Luensmann Offsite Water Main Ext PH1
Solicitation Number: CO-00717
Job No.: 23-1043

ADDENDUM 1
11/16/2023

PLAT NO. _____
JOB NO. 12473-09
DATE MARCH 2023
DESIGNER CD
CHECKED MP DRAWN CD
SHEET C3.02

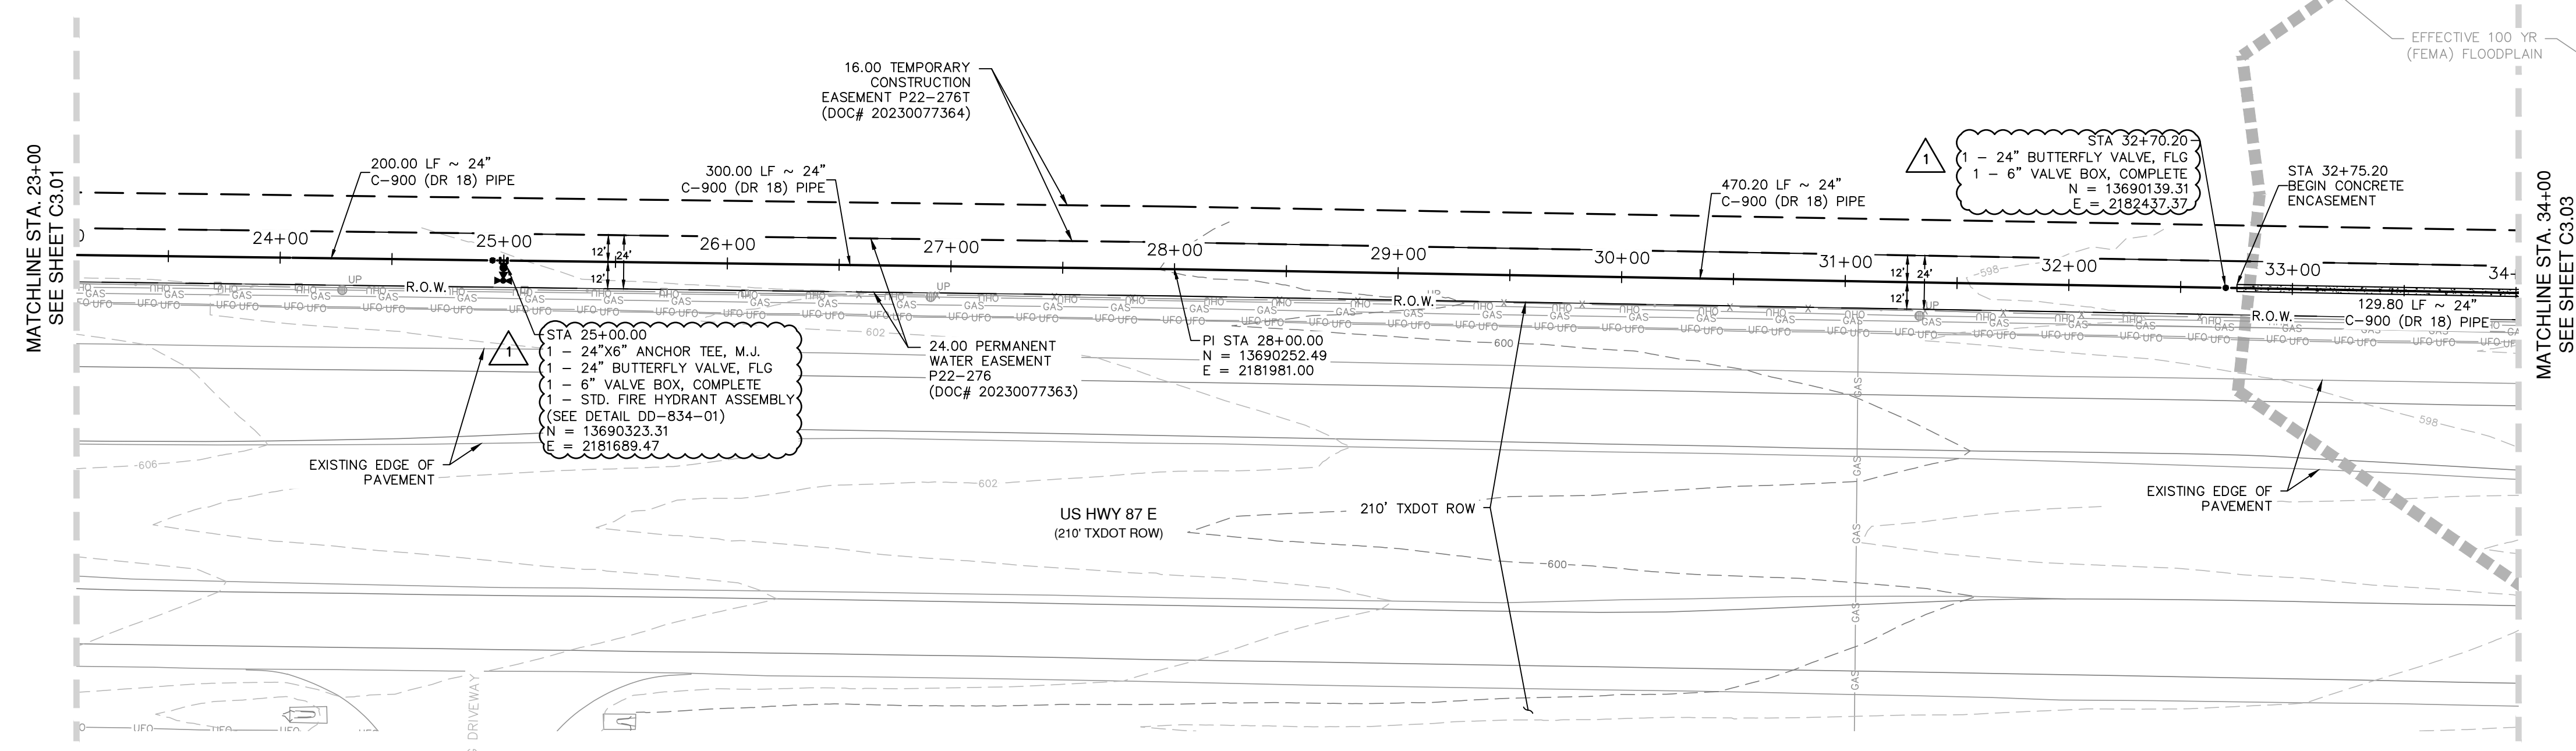
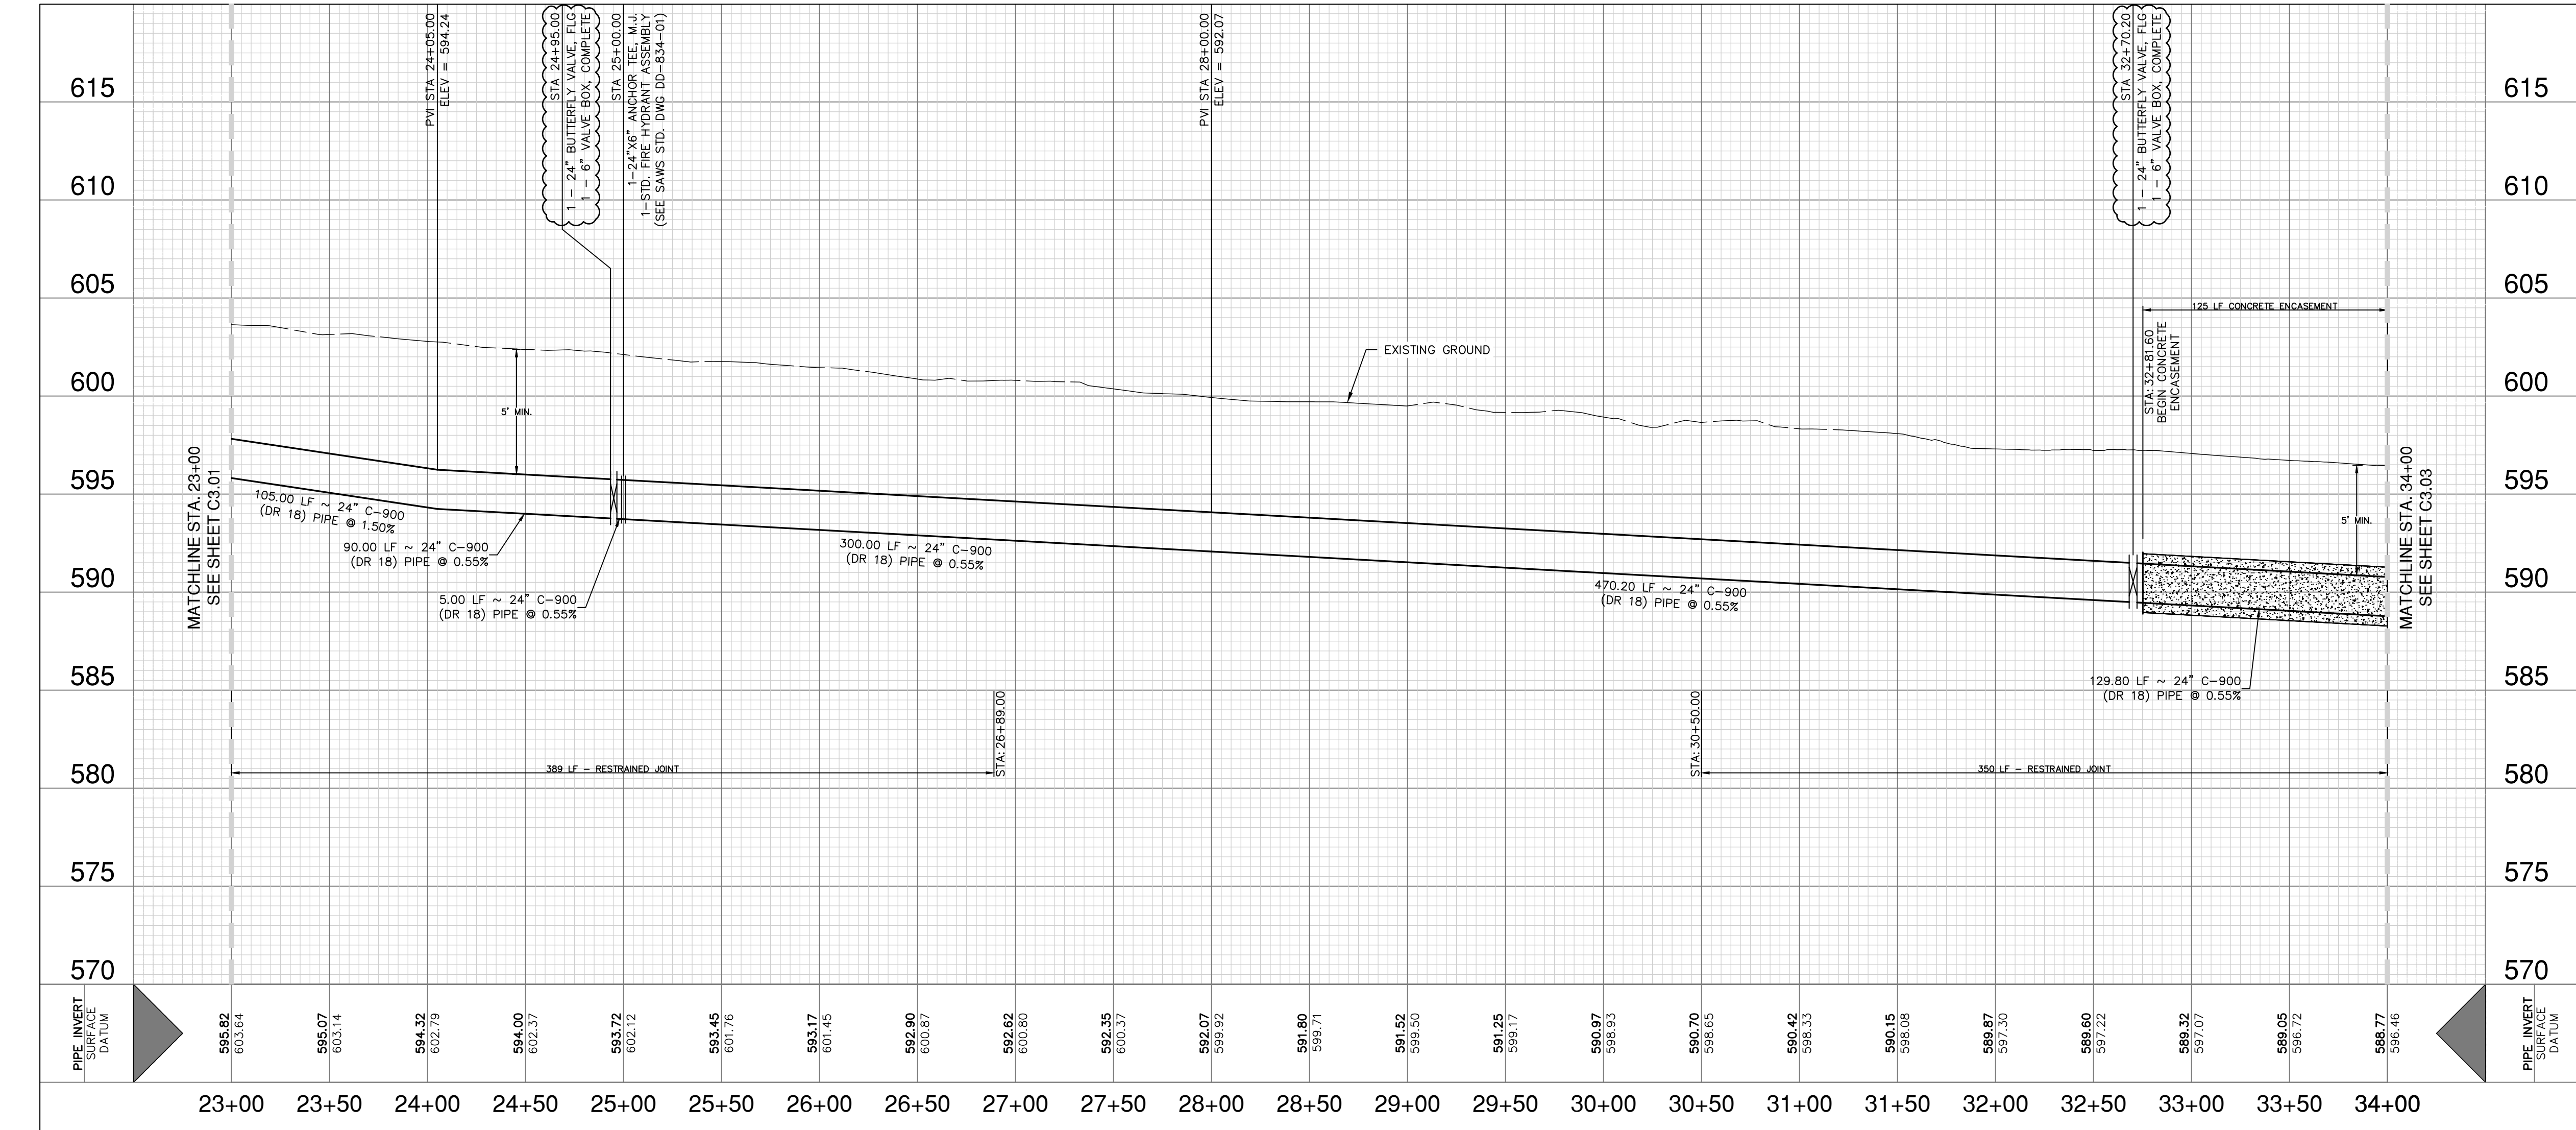
4. Sheet C3.02: Water Main Plan and Profile Sta 23+00 to 34+00 – Remove in its entirety and replace with the attached document.
 - Revised 24" Butterfly valve to be Flanged.

PLAT NO.
JOB NO. 12473-09
DATE MARCH 2023
DESIGNER CD
CHECKED MP DRAWN CD
SHEET C3.03

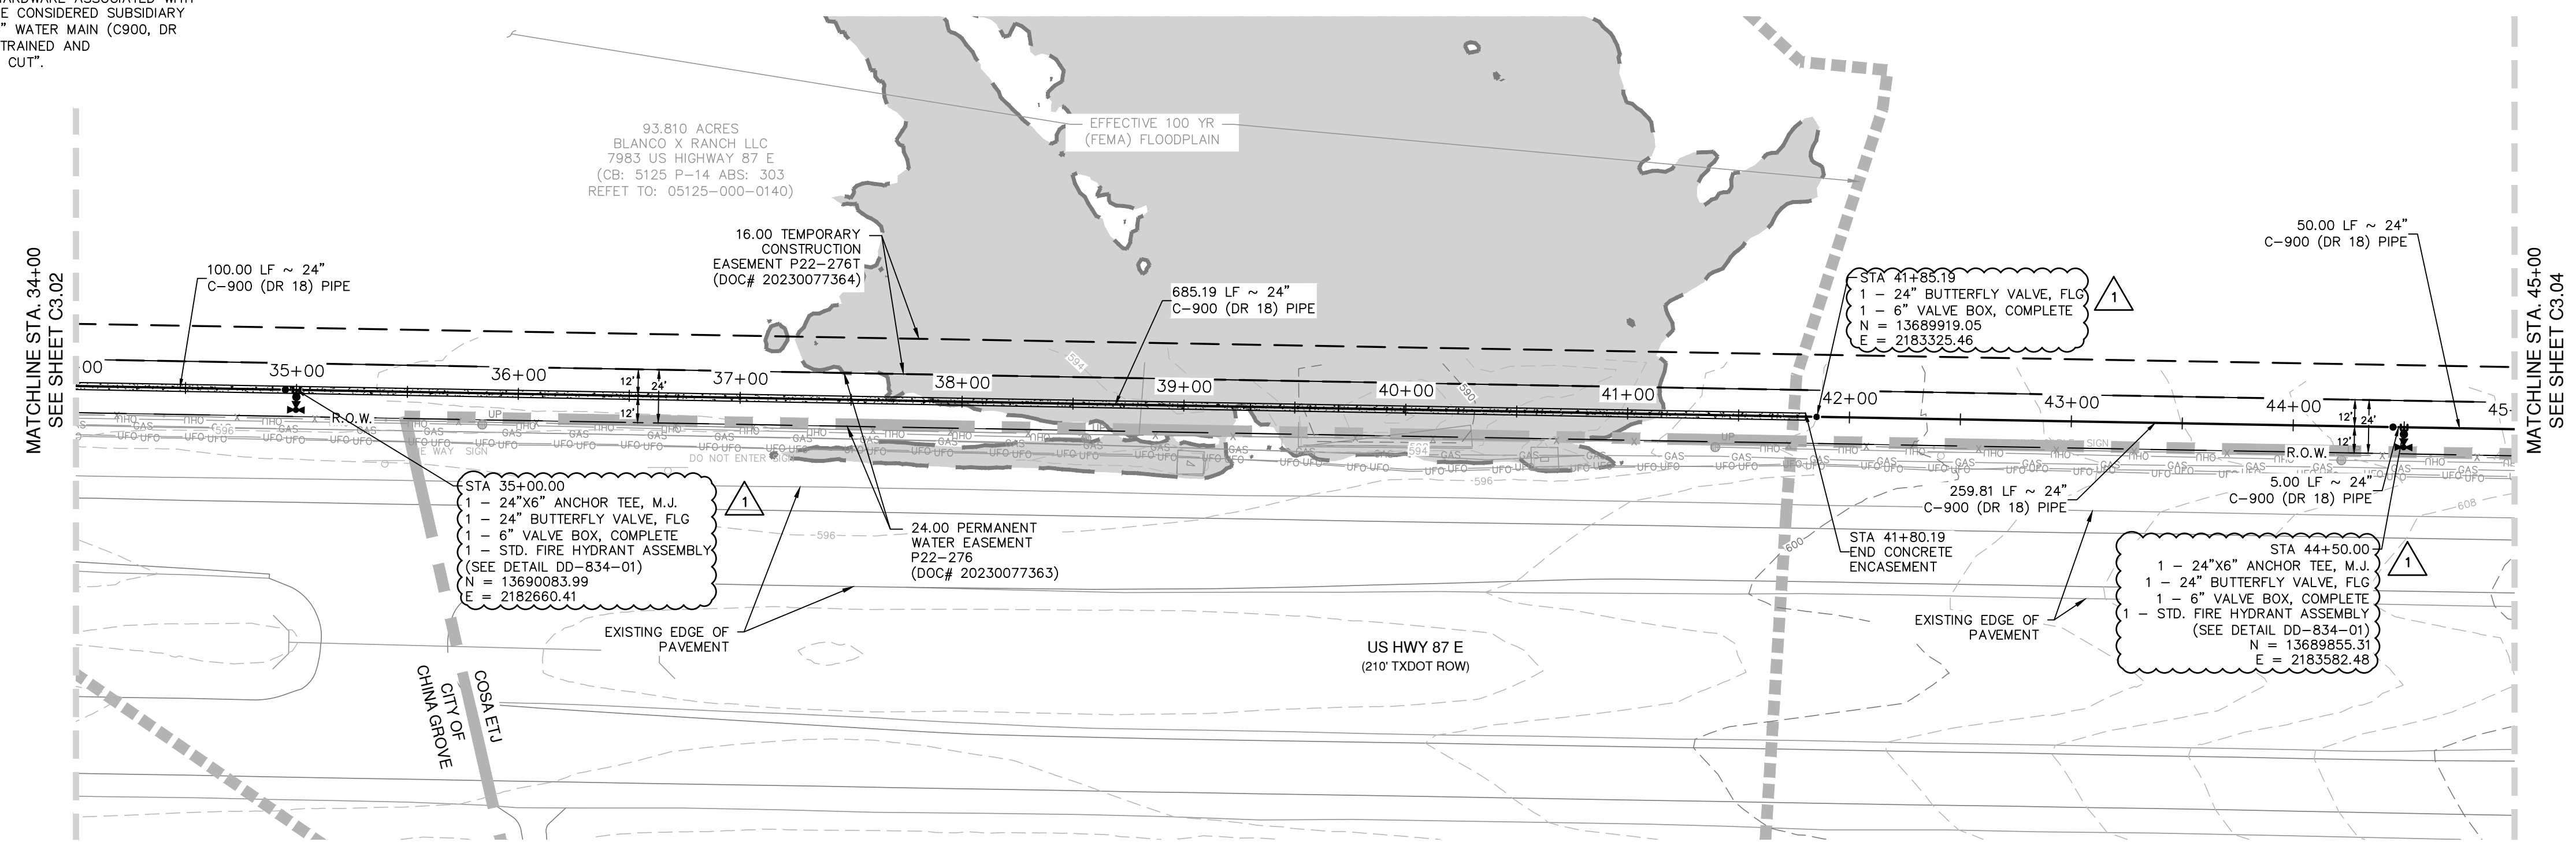
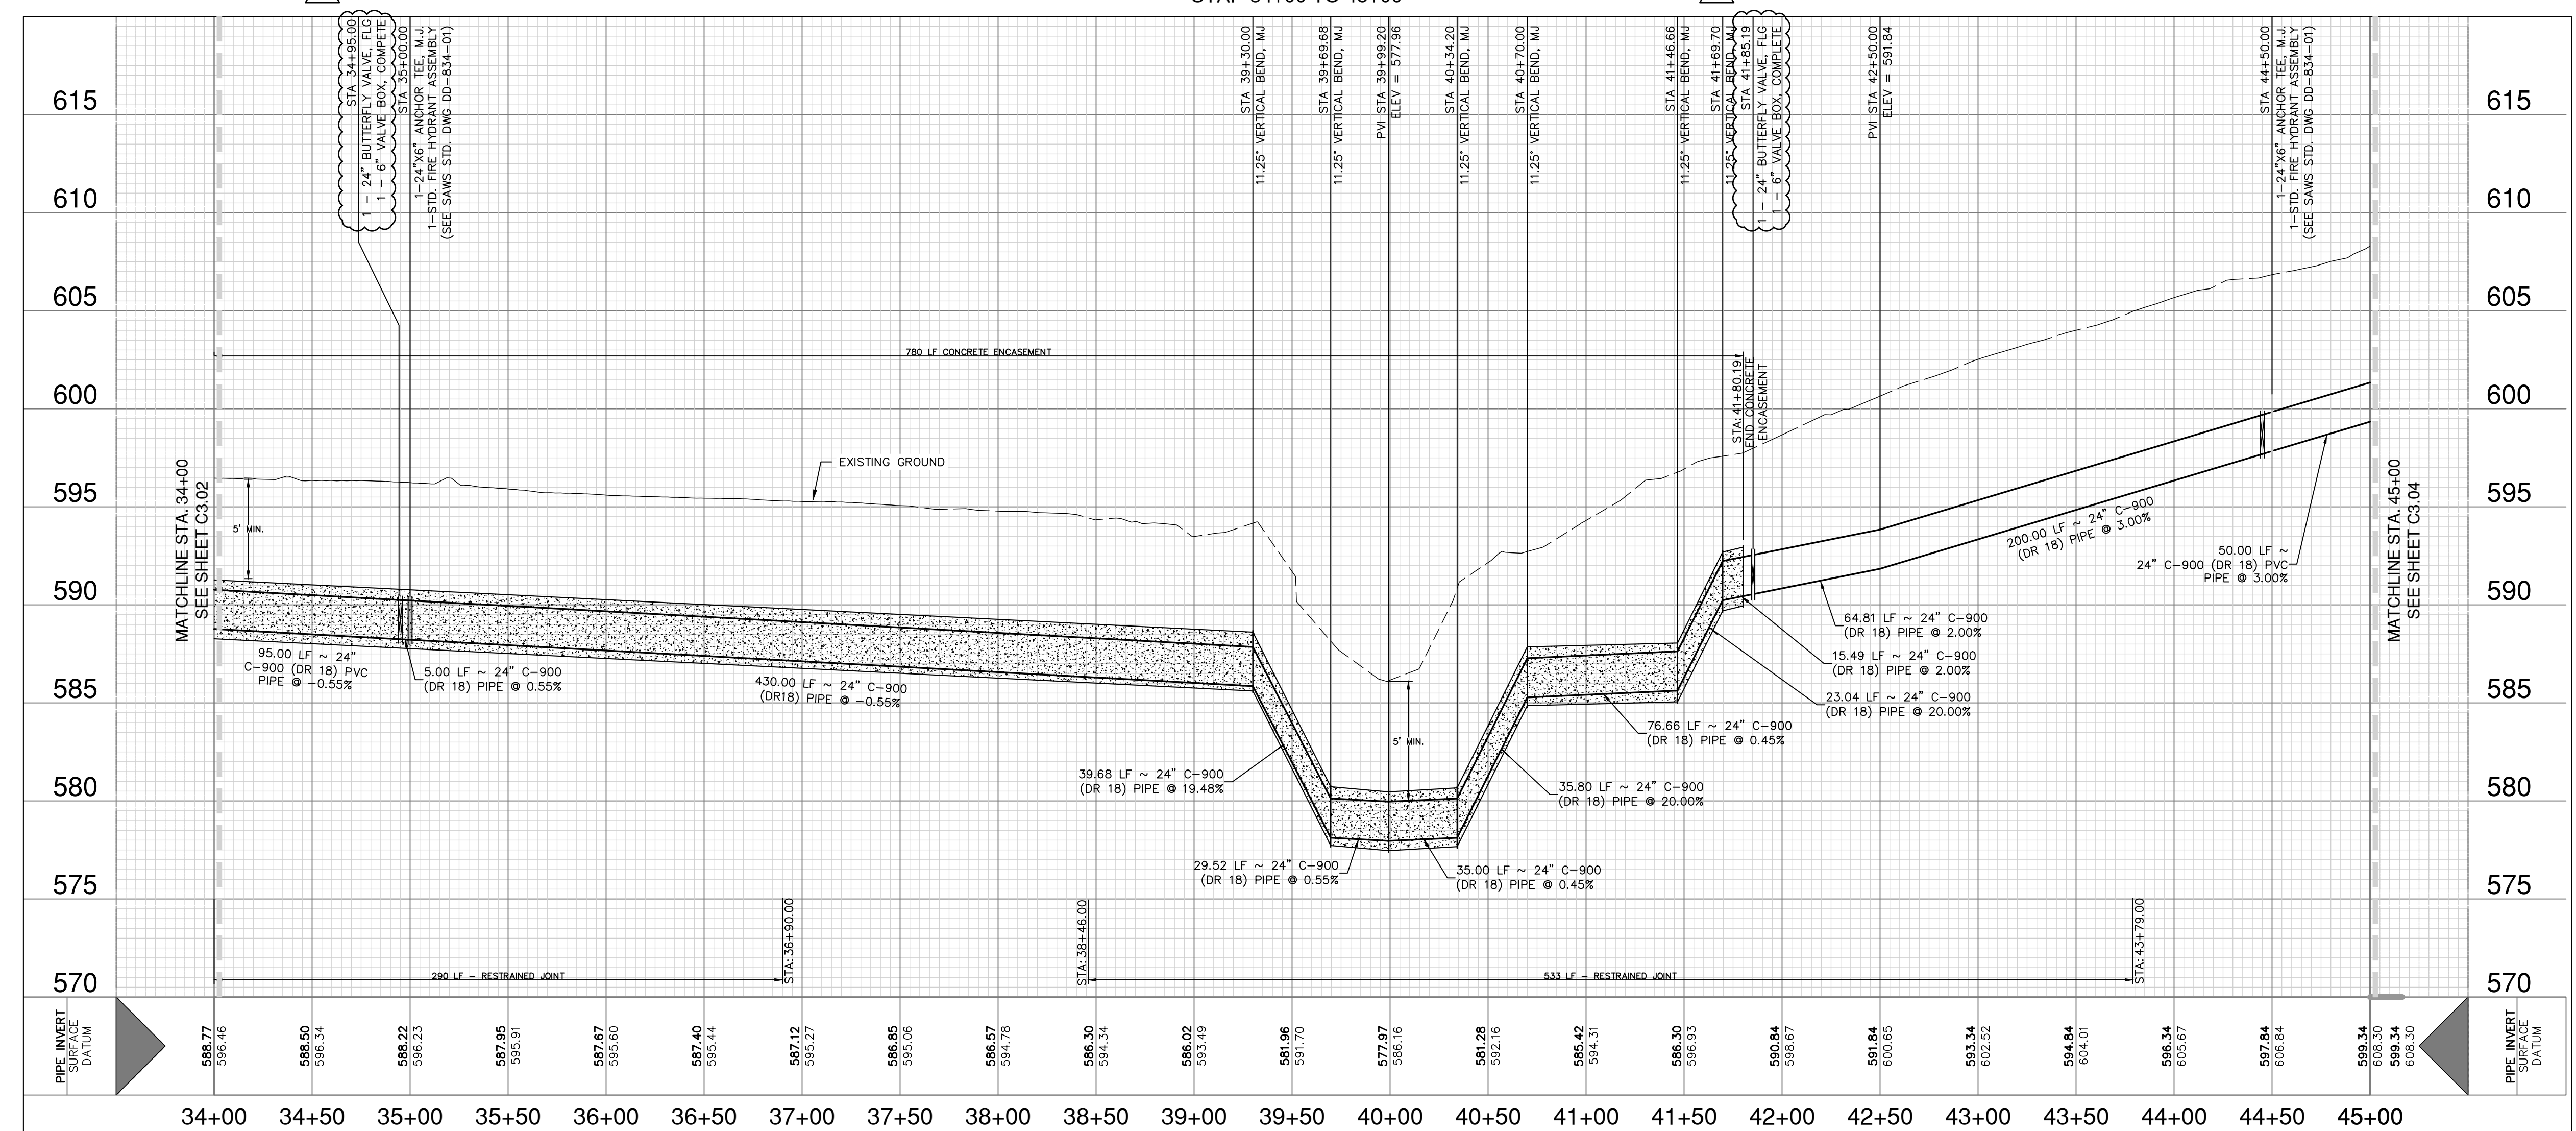
5. Sheet C3.03: Water Main Plan and Profile Sta 34+00 to 45+00 – Remove in its entirety and replace with the attached document.
 - Revised 24" Butterfly valve to be Flanged.
